To: Plan Holders for SLN Terminal Expansion  
Salina Regional Airport  
Salina, KS  
AIP Project Number 2-20-0072-054/055-2024

Transmitted herewith Addendum No.2 to the Issued for Bid Contract Documents, Specifications and Plans dated July 2, 2024 for improvements to the Salina Regional Airport.

**ADDENDUM NO. 3**  
**TO**  
**CONTRACT DOCUMENTS, TECHNICAL SPECIFICATIONS, AND**  
**PLANS**  
**FOR IMPROVEMENTS TO THE**  
**SALINA REGIONAL AIRPORT**  
**SALINA, KS**  
**AIP PROJECT NUMBER 2-20-0072-054/055-2024**

**C1** ENTRY CANOPY ROOF PLAN  
 1/4" = 1'-0"

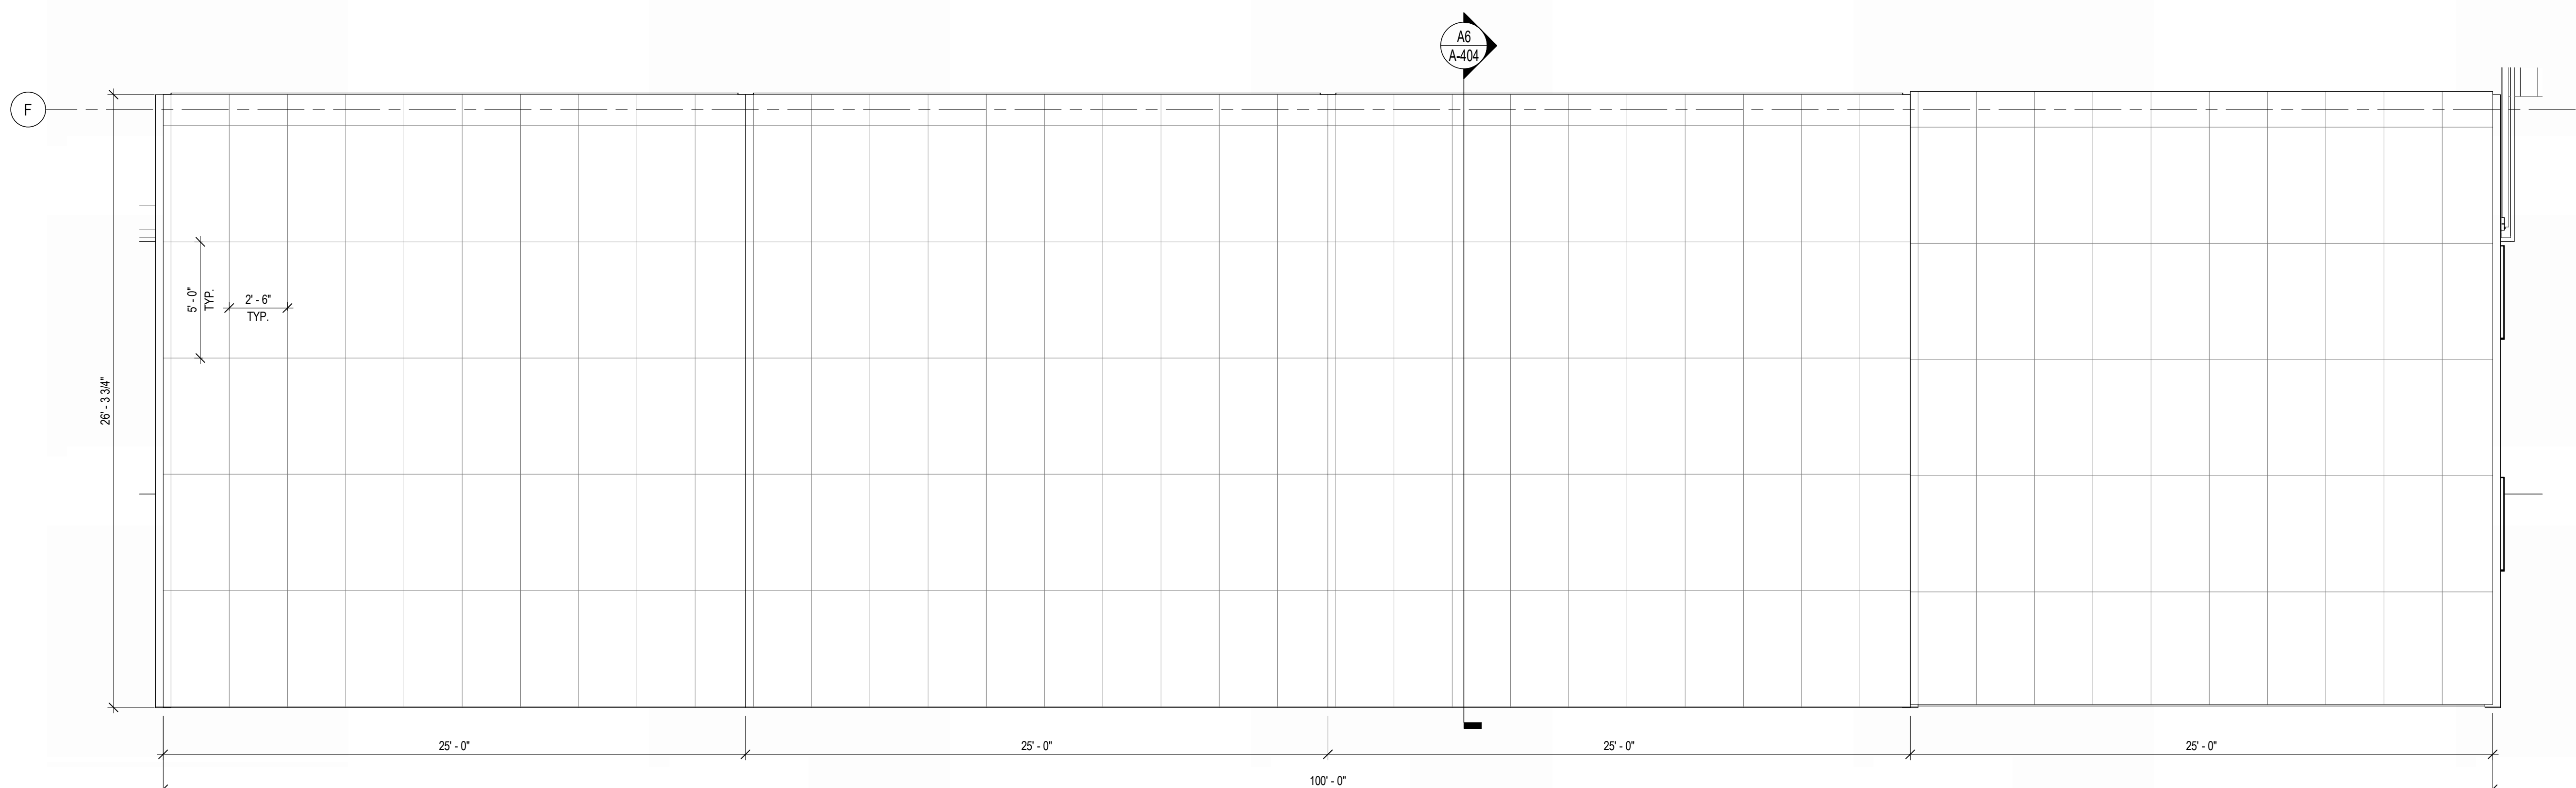
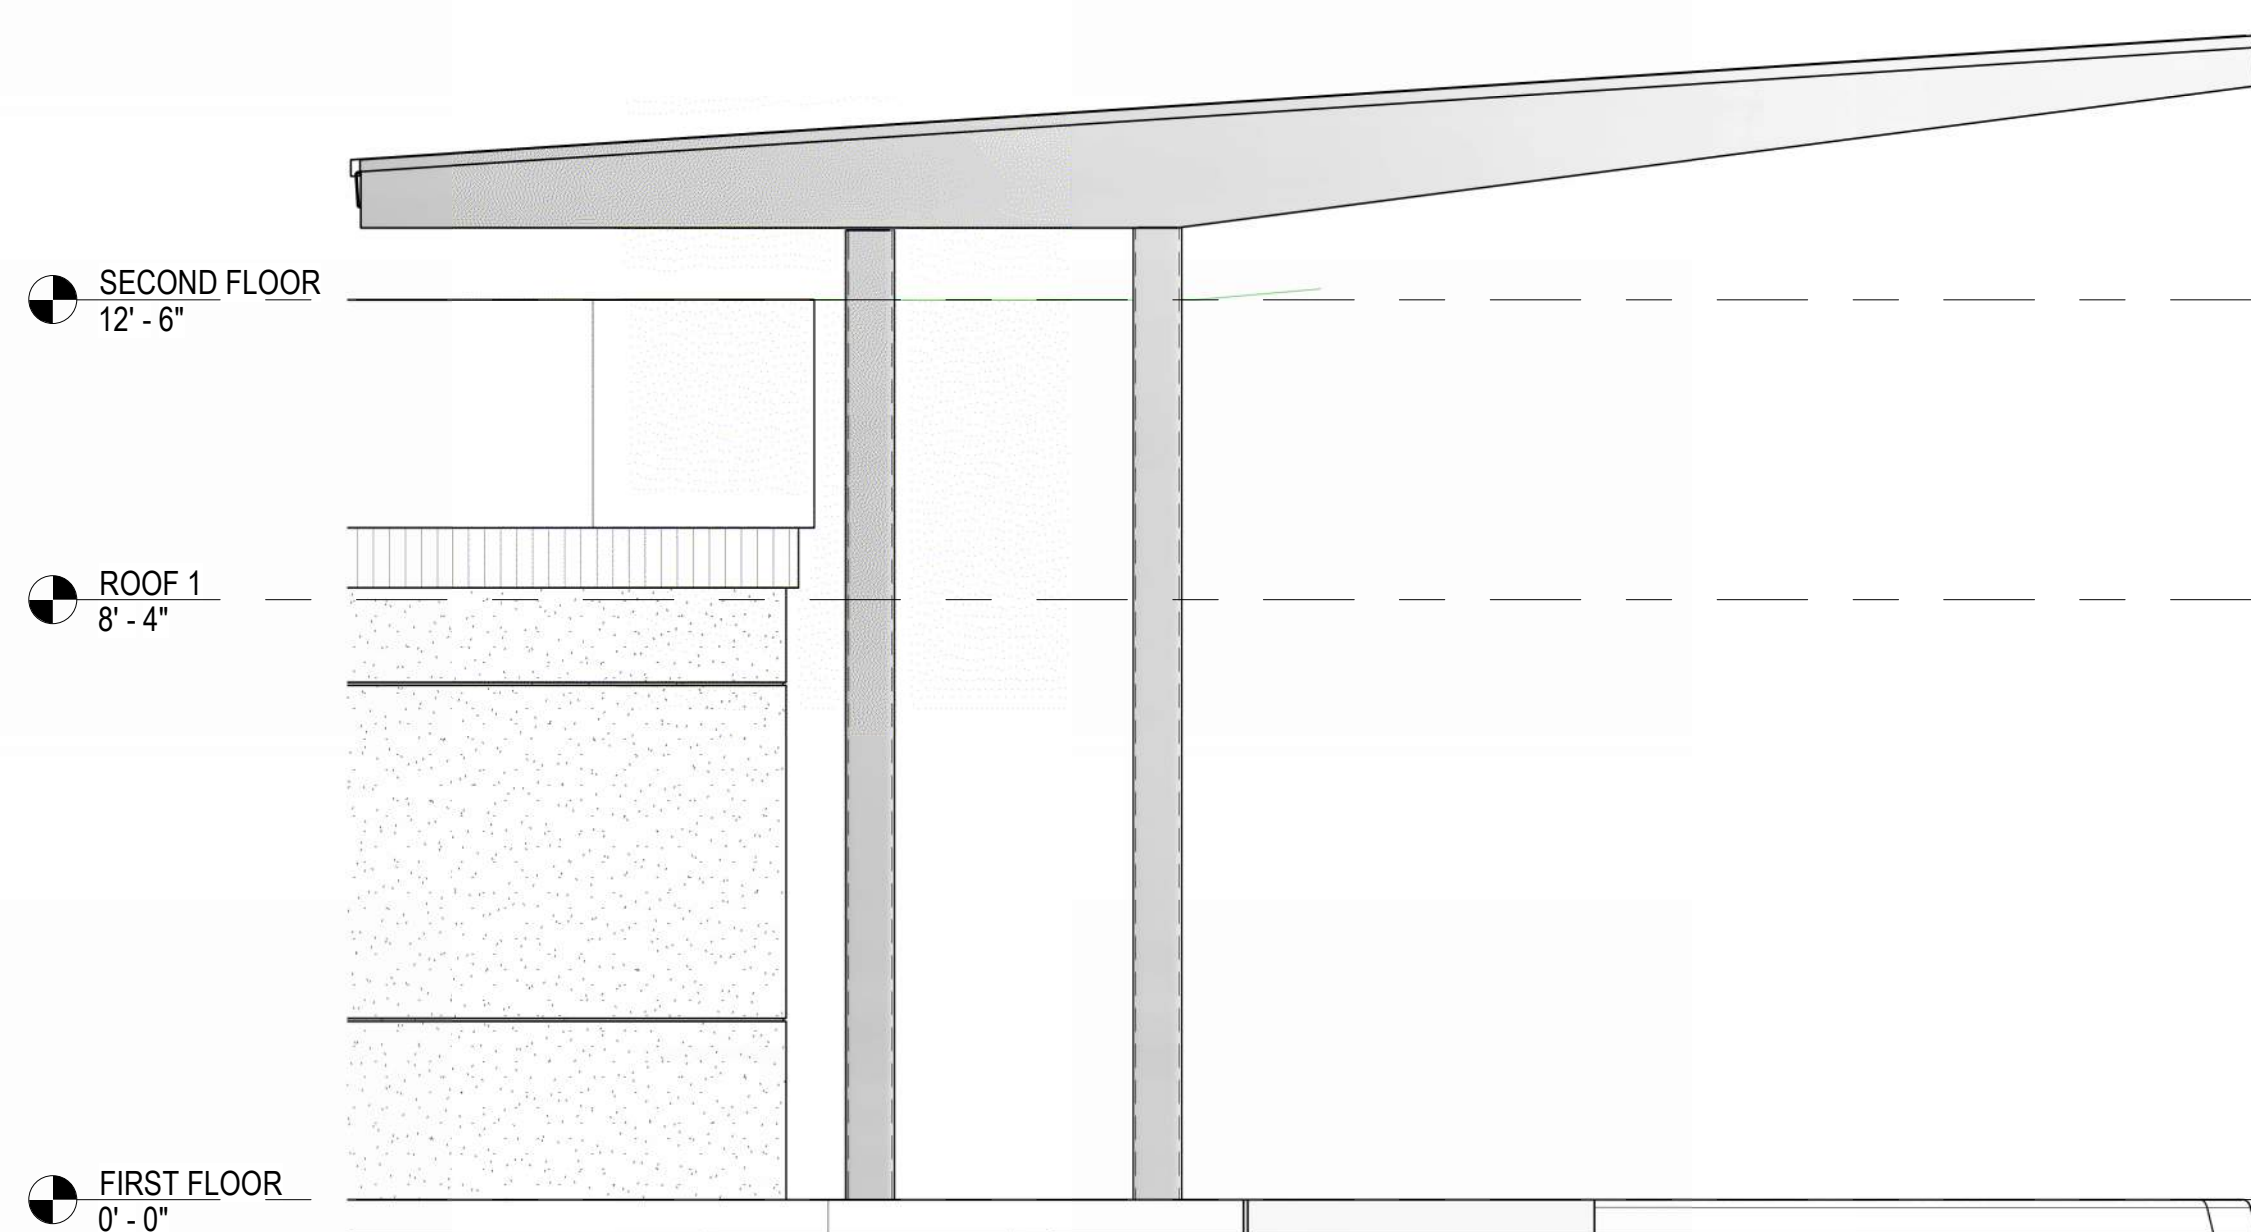
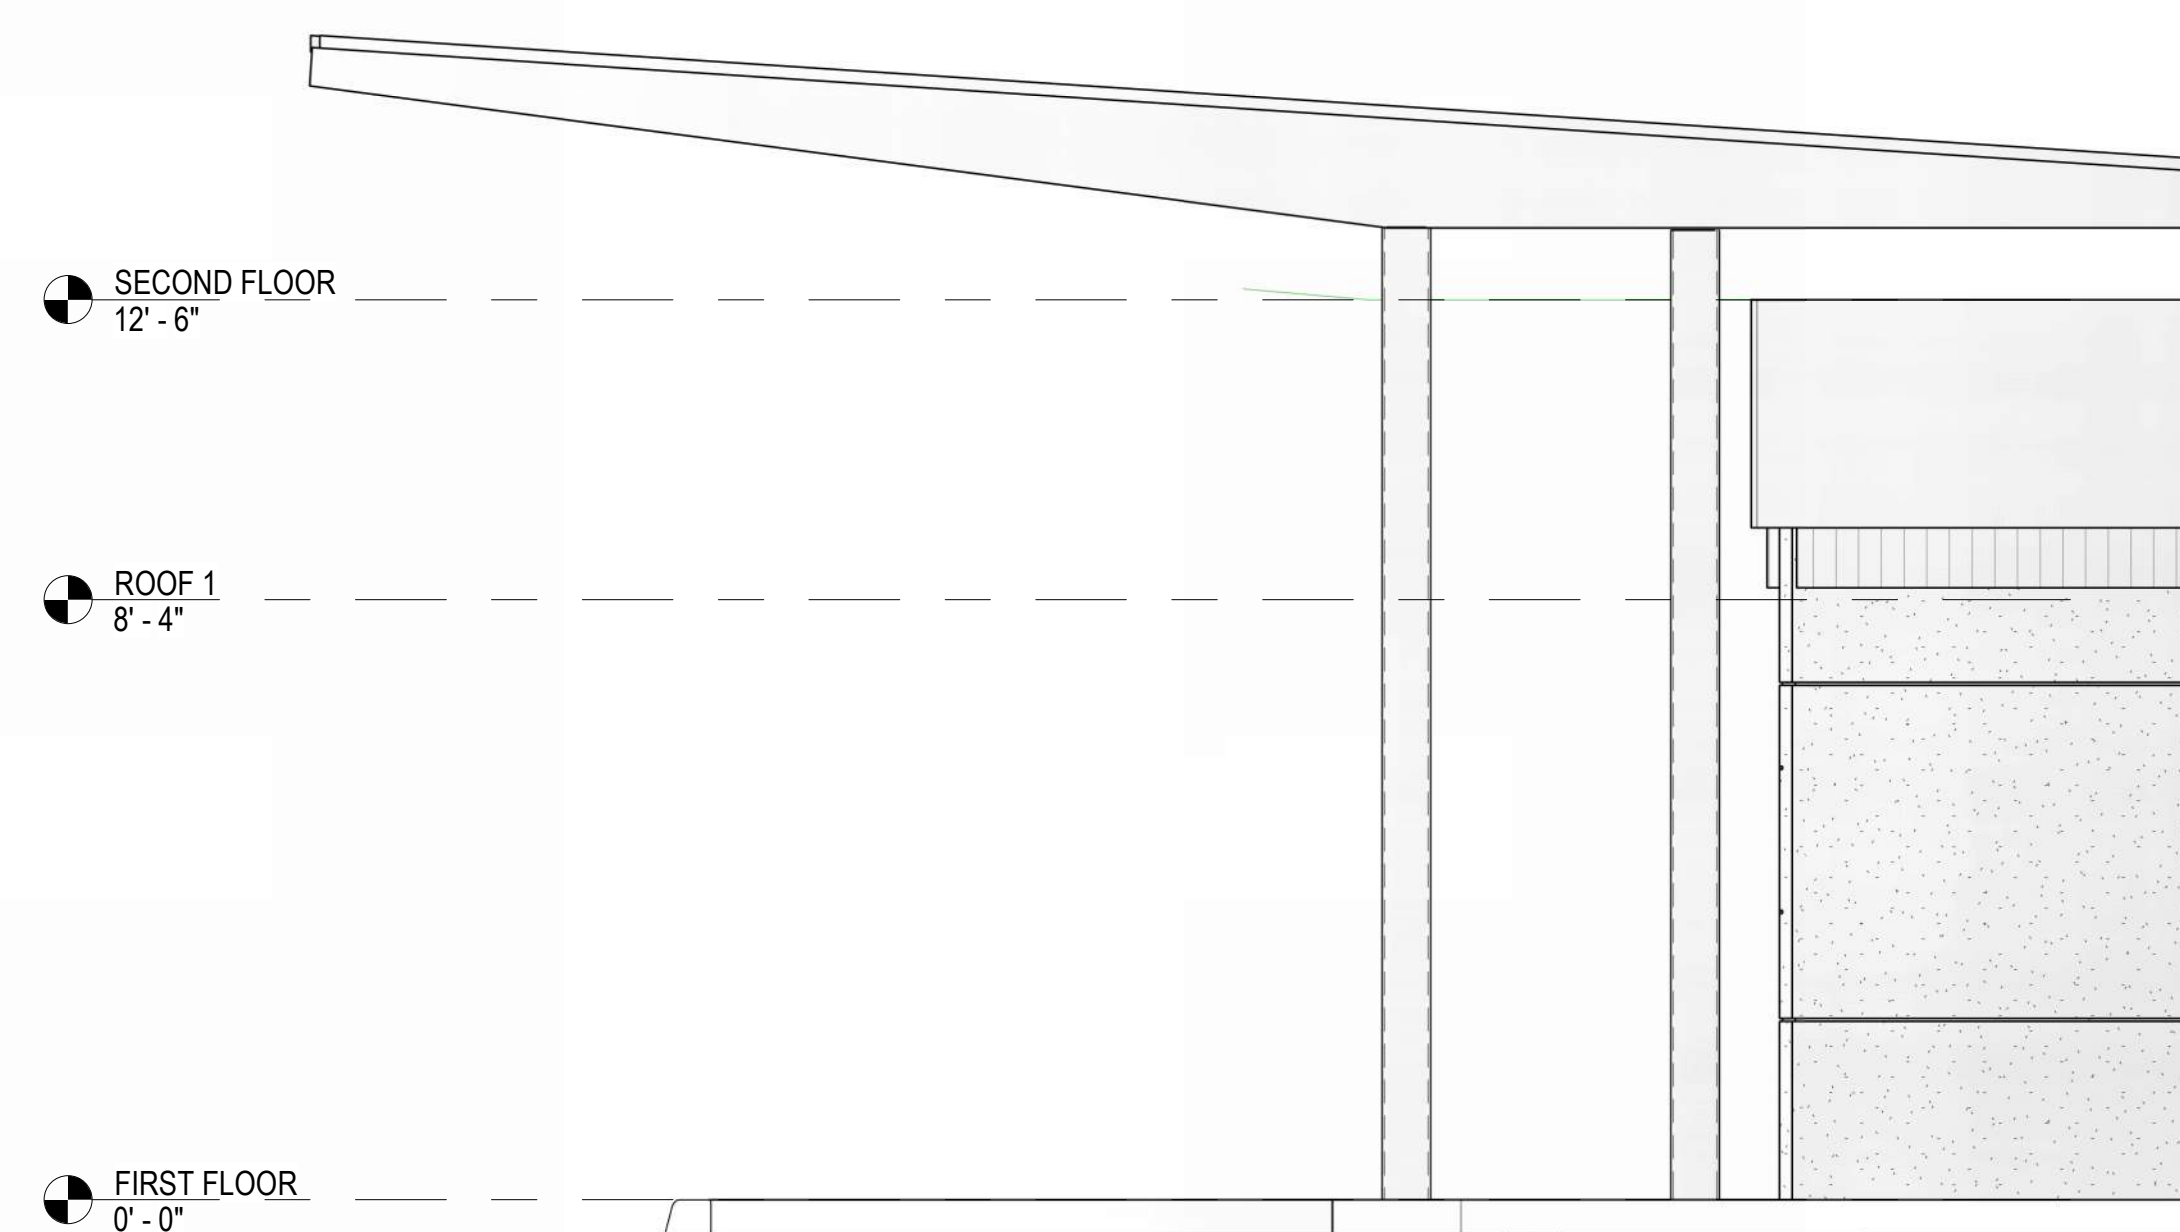
**A404 ENLARGED ENTRY CANOPY PLANS AND DETAILS**

**Justification:** For clarification of Entry Canopy roof panel and dimensional information.
